AGENDA
City of Gig Harbor Design Review Board
Meeting of March 27, 2025
Civic Center, 3510 Grandview Street
5:30 PM

- h. Public Comment (See Assistance Memo)
 - i. Discussion and Voting
1. **GIG HARBOR HOLDING CO., LLC, 1613 S. CAPITAL OF TEXAS HWY #20, AUSTIN, TX 78746-6558: Rosedale Preliminary Plat, (PL-PPLAT-22-0002, (PL-DR-22-0025) and (PL-SEPA-22-0008).** The subject site consists of two parcels totaling 38.63 acres. The applicant proposes plating the 38.63-acre site into approximately 31 single-family lots with access from Rosedale Street. Most of the lots and interior roadways will be located on the northern portion of the existing parcels. The site is located at 5200 Rosedale St., | Parcel no. 0221063035/0221063034.

**COMMUNITY DEVELOPMENT DEPARTMENT
PLANNING DIVISION
STAFF REPORT**

TO: Design Review Board
FROM: Planning Staff – Jeremy Hammar, Senior Planner
DATE: March 13, 2025

SHEET TITLE: OVERALL GRADING PLAN
ROSEDALE PRELIMINARY PLAT
CLIENT: GIG HOLDING COMPANY LLC
1900 SAINT JAMES PL STE 300
AUSTIN, TX 77056
CONTACT: CHARLES DUFFLEY PHONE: 361-730-3630

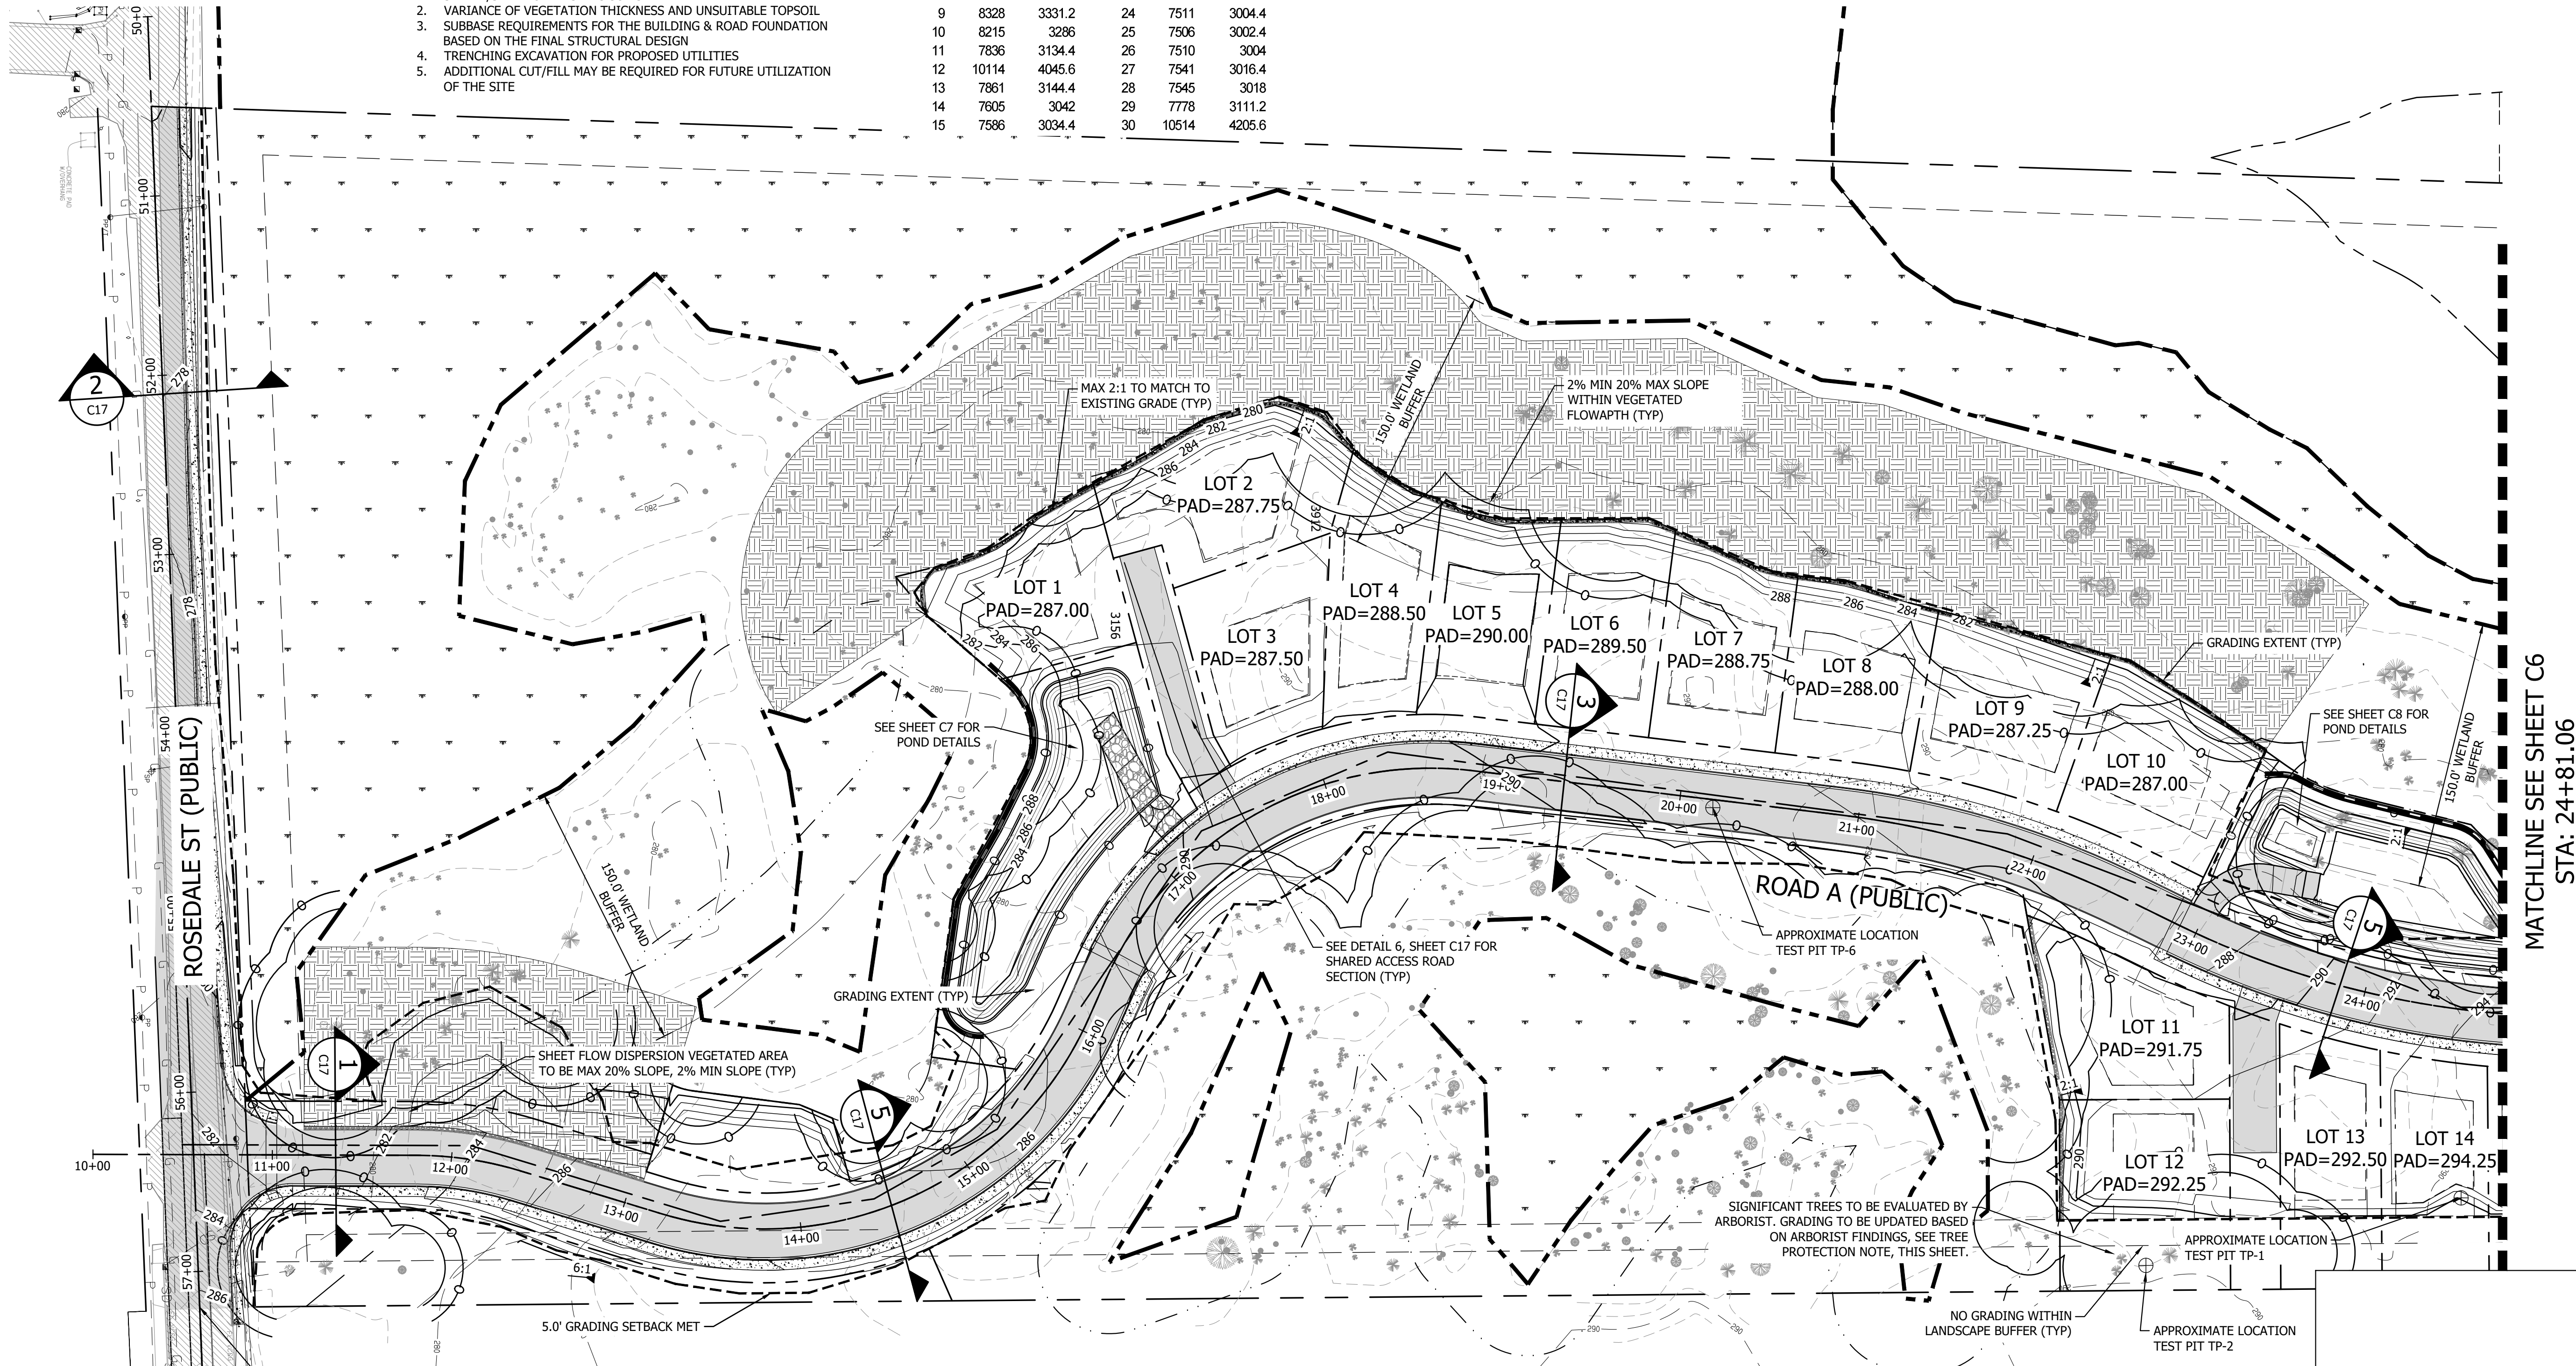
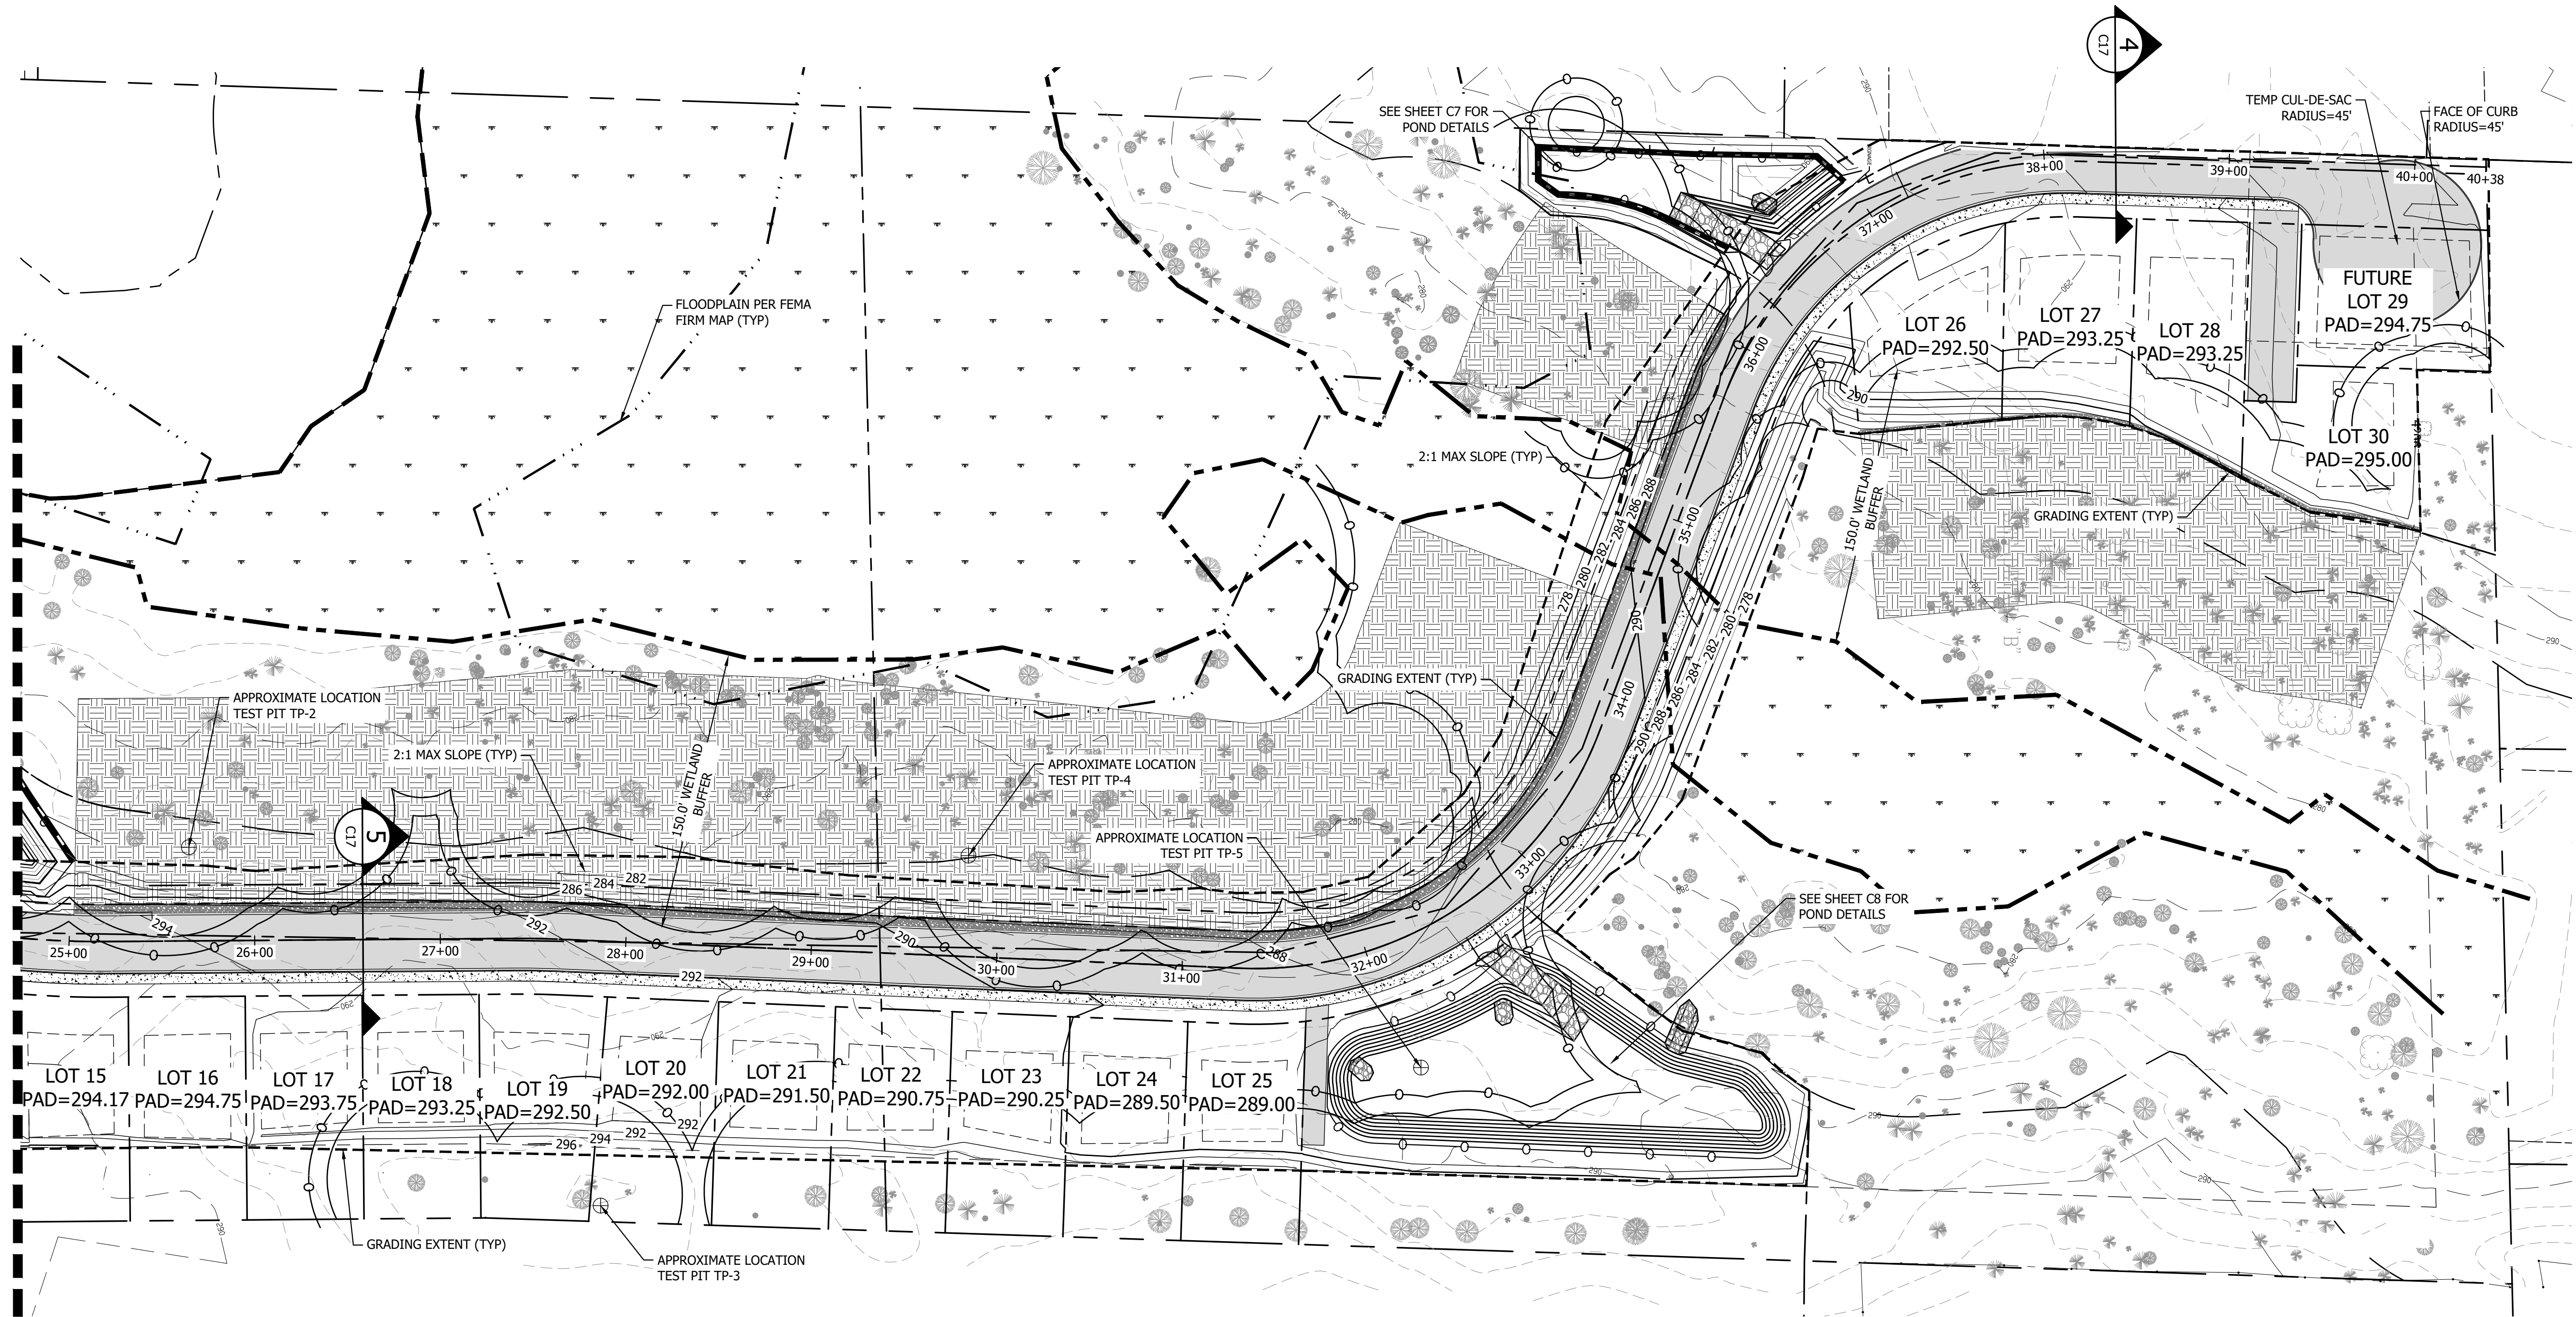
Staff Analysis: The City considers cuts and fills on a project to be balanced when cut and fill on site are within 10% of one another. The applicant submitted plans dated March 7, 2025 (Exhibit B), and the Sheet C5, Overall Grading Plan, indicates an estimated 7,025 cubic yards of cut and 53,500 cubic yards of fill – with a net 46,475 cubic yards of fill. The applicant is requesting up to 60,000 cubic yards of fill as the necessary amount may change at the time final grading plans are submitted as part the civil review.

Response: On previous projects City Staff has indicated that a balanced site is one where the cut and fill quantities are within 10%. Currently, the preliminary cut and fill quantities are significantly higher. This is mainly due to the reasons below:

In order to meet the wetland criteria required as part of the stormwater manual, specifically Minimum Requirement #8 – Wetland Protection, the wetland hydroperiod must be maintained to the greatest amount feasible. To maintain this hydroperiod, the site is proposing to use dispersion for the majority of the site. These dispersion systems must be located topographically higher so that stormwater is able to slope down to existing grade and sheet flow to the ultimate discharge point on site (the wetlands). This requires the improvements to be built up at a higher elevation, requiring the large amount of fill and not allowing for earthwork to balance out.

The current plans show a total of 46,475 CY of fill required. This is based on a preliminary design, and it is assumed grading changes may be required through the permit process and as construction drawings evolve. During this time additional material may be required in order to make these changes, some of which cannot be determined until the time of construction documents. In order to capture these changes and prevent the need to go back to DRB for any grade changes above the current plan of 46,475 CY of fill, we are requesting additional fill quantities up 60,000 CY. Plan exhibits have been included on sheets C11 and C12 to give a visual representation of where the material will be placed on how the site will be raised up. While it is not anticipated that the site will require this much material to be brought in, this 60,000 CY of fill is a conservative number that allows for flexibility during the full civil engineering development phase without the need to go through multiple DRB meetings for the same issue.
